UNITED STATES PATENT AND TRADEMARK OFFICE

10/577,996

Office Action Summary	Application No. 10/577,996	Applicant(s) HERMANS ET AL.	
	Examiner BENJAMIN P. LEE	Art Unit 3641

DETAILED ACTION

FIG. 1

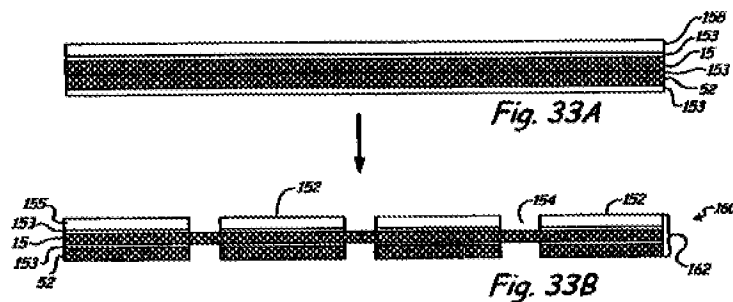
8. In regards to claim 6, Kim as modified by Andersen discloses that at least one metal layer is multi-directional (see Andersen figures 1 and 2 following). Note that the metal layer construction, when modified by Andersen, teaches a wire mesh layer with "multiple directions".
